**PEA RIDGE PUBLIC SERVICE DISTRICT
CABELL COUNTY, WEST VIRGINIA**

CONTRACT #4 – ROUTE 2 SOUTH SANITARY SEWER EXTENSION

ADDENDUM #2

JULY 24, 2023

SHEET No.
1

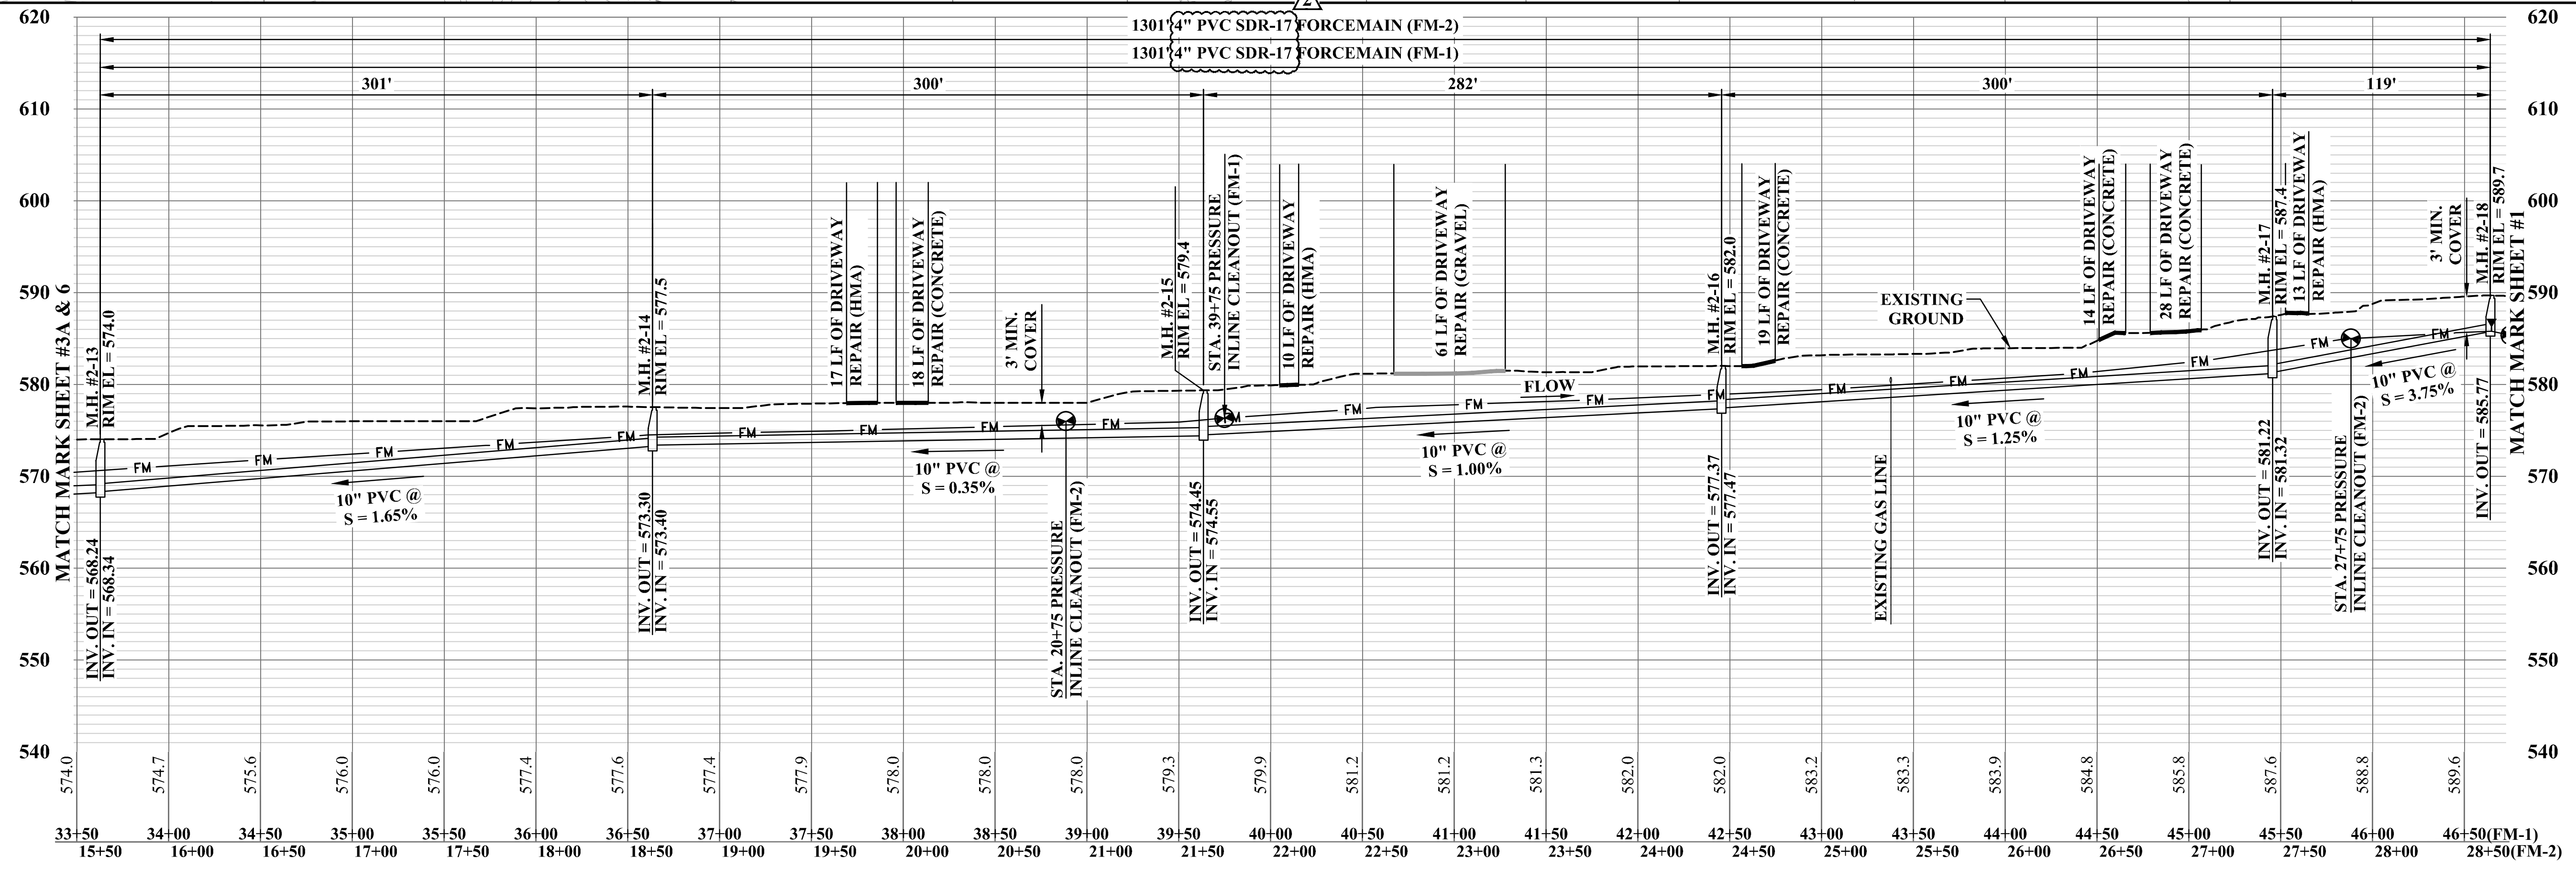
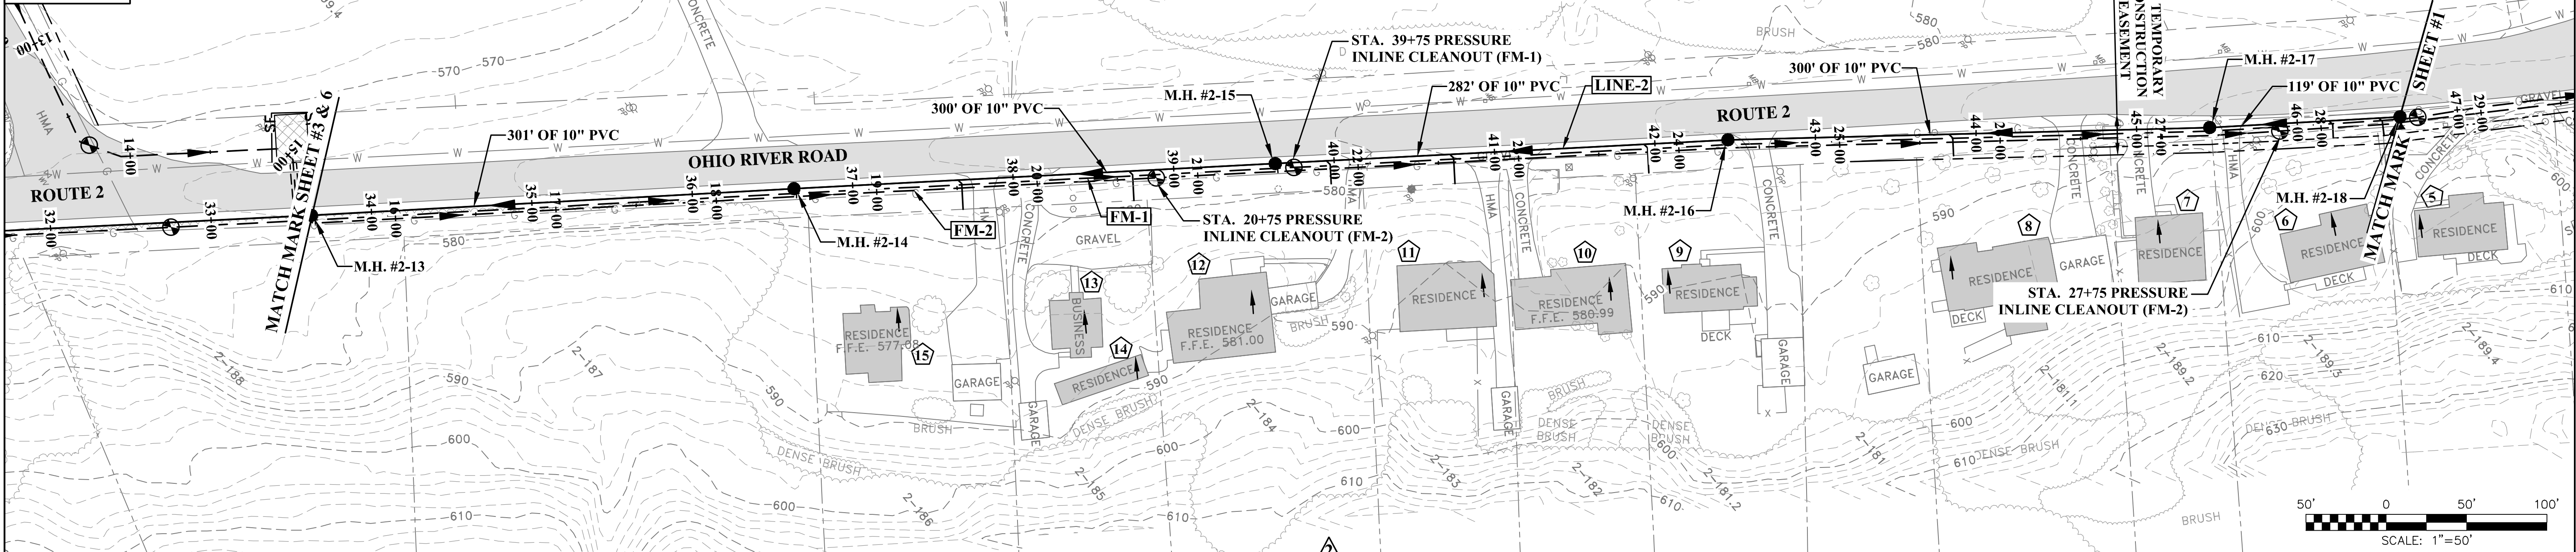
Will you add a bid item and detail for the 3" inline cleanout found on pages 1, 2, 6, 7, and 8 of the contract drawings?

Bid item 20a has been added for the 3" inline cleanout. It is described in the Standard Detail on Sheet DET-4.

SHEET No.
8

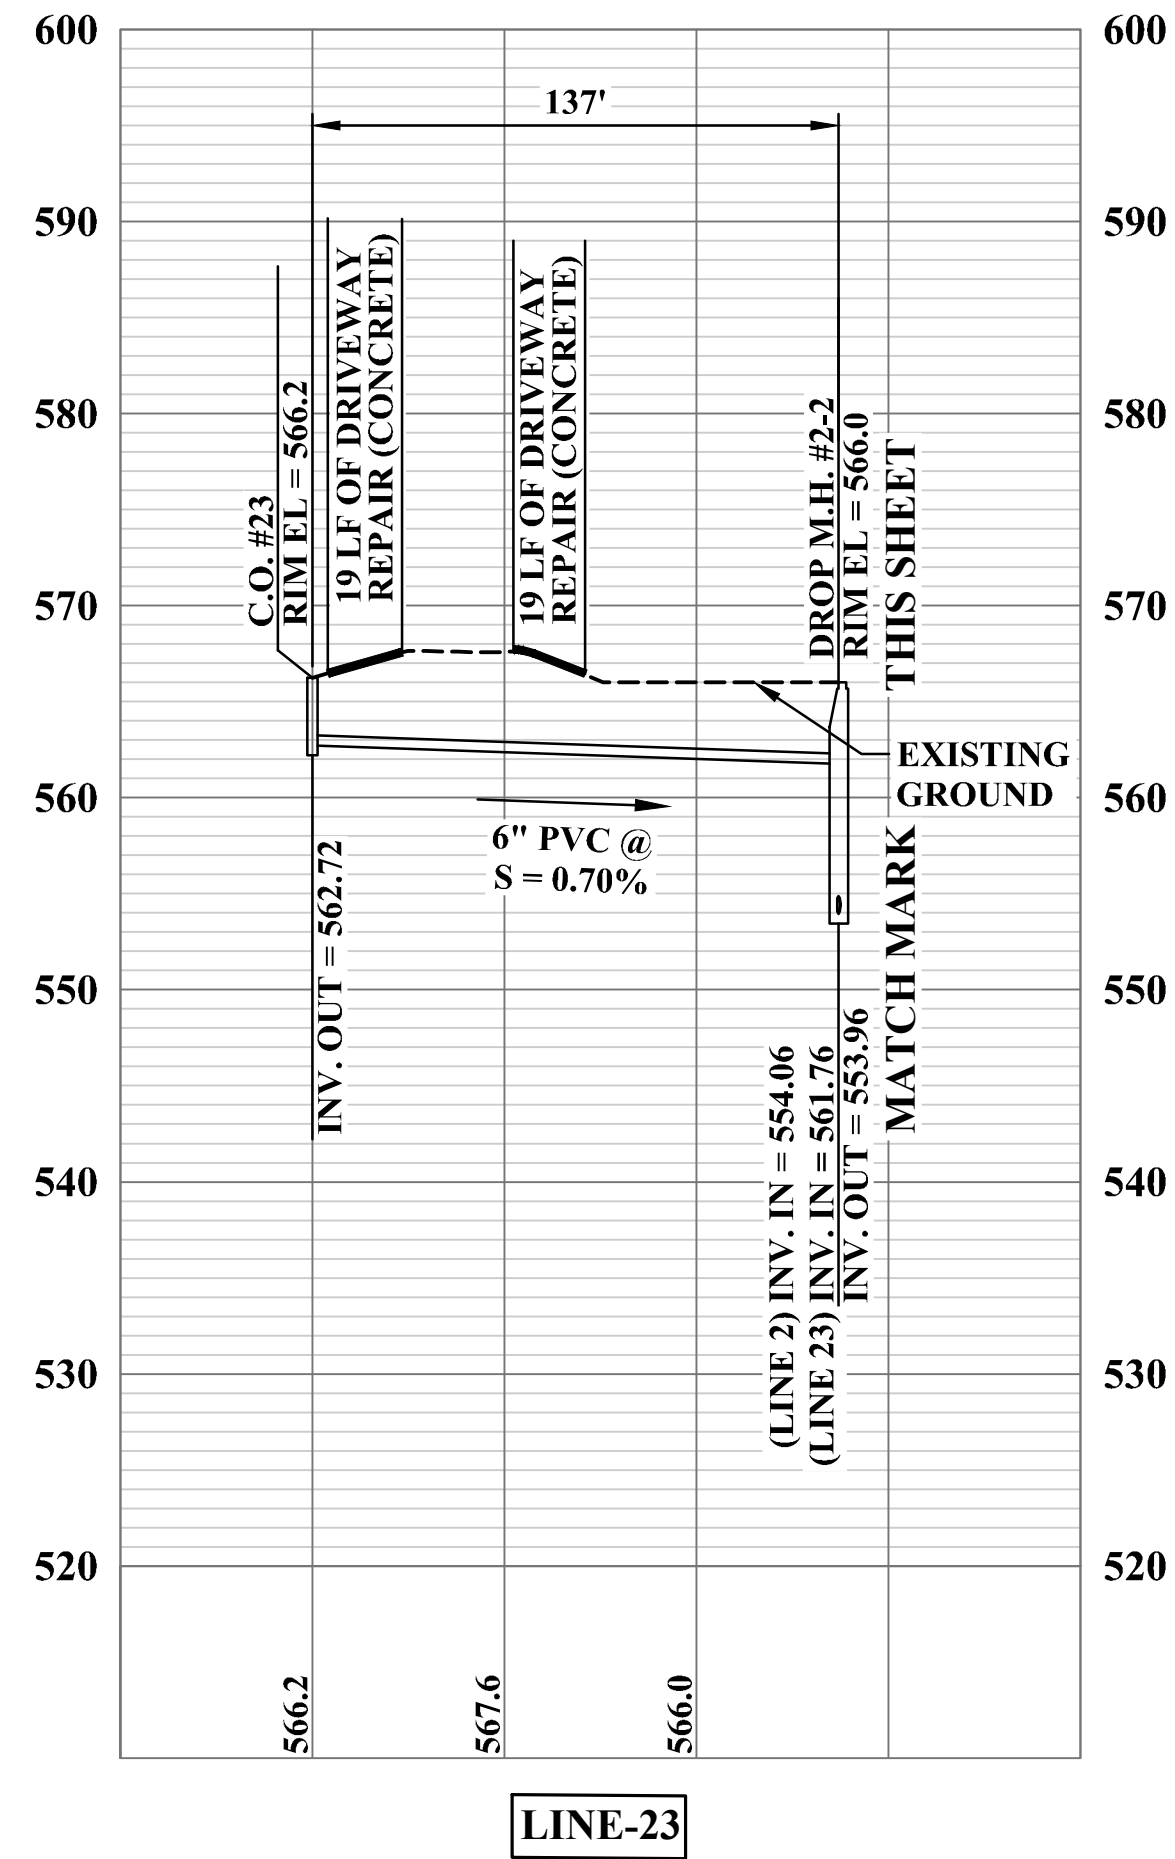
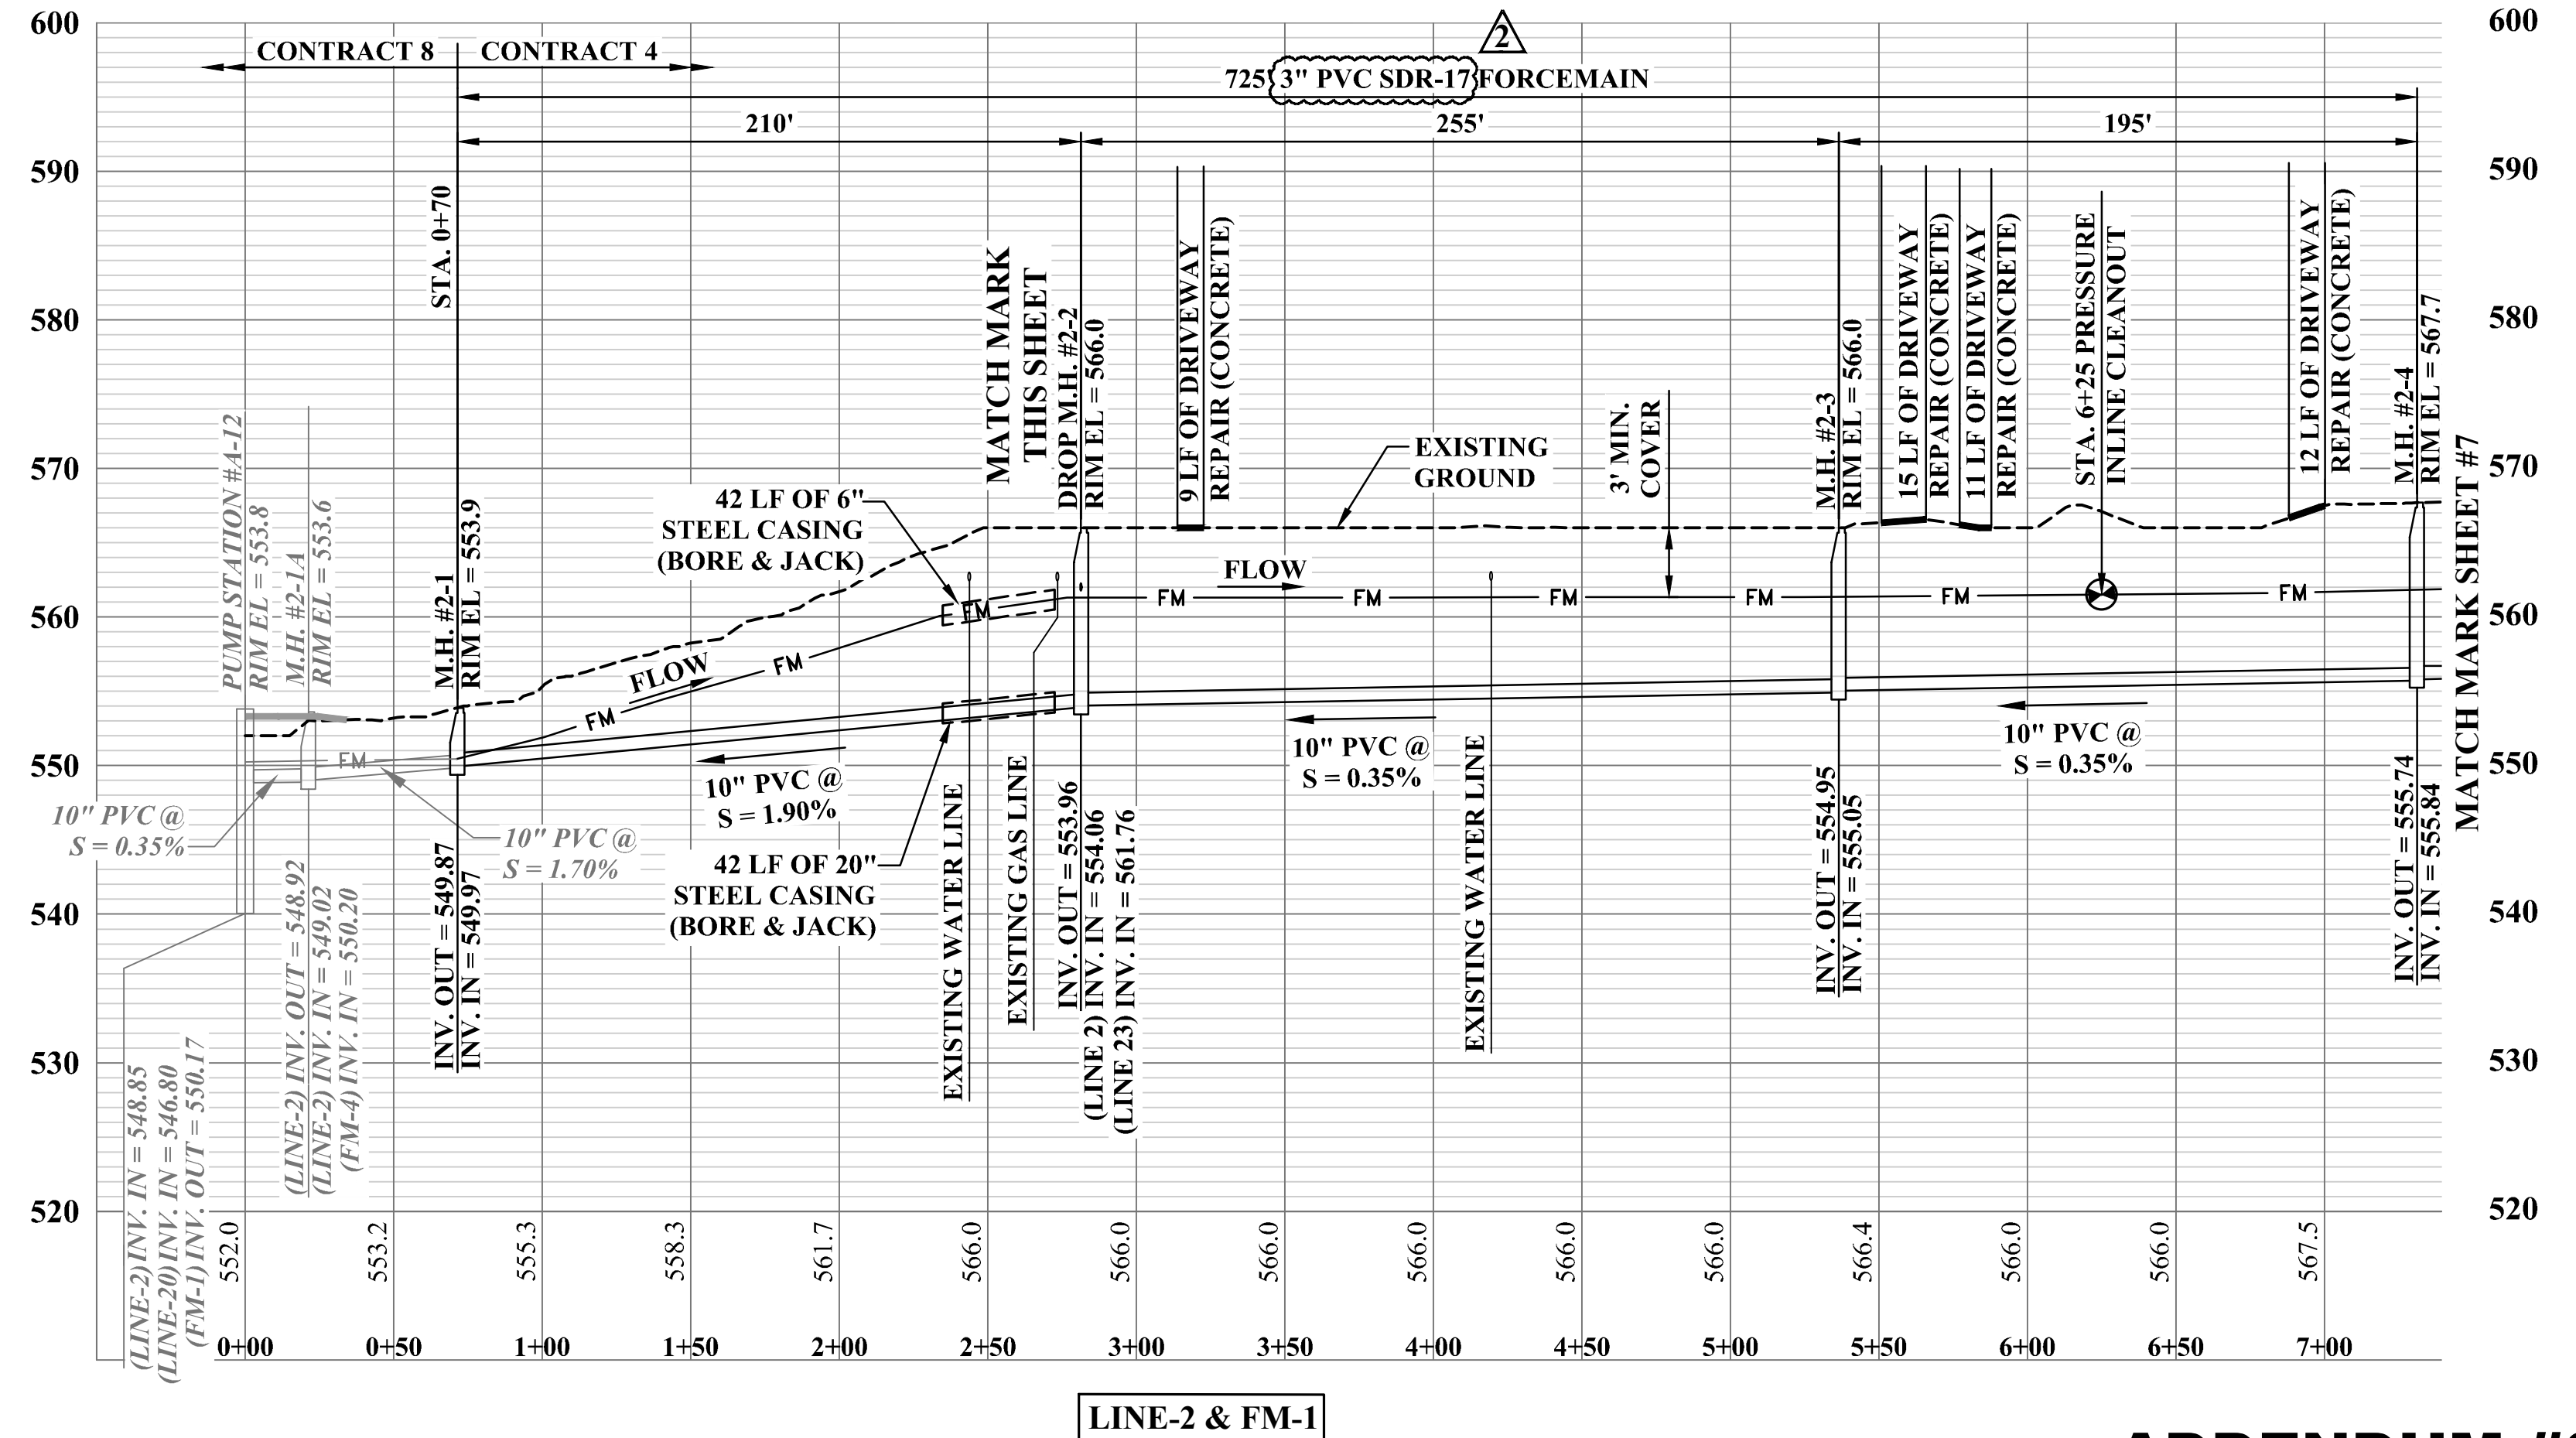
Will you add a bid item and detail for the 2.5" inline cleanout found on pages 8, 10, and 11 of the contract drawings?

The line size has been revised. A 2.5" to 3" cleanout is not needed.
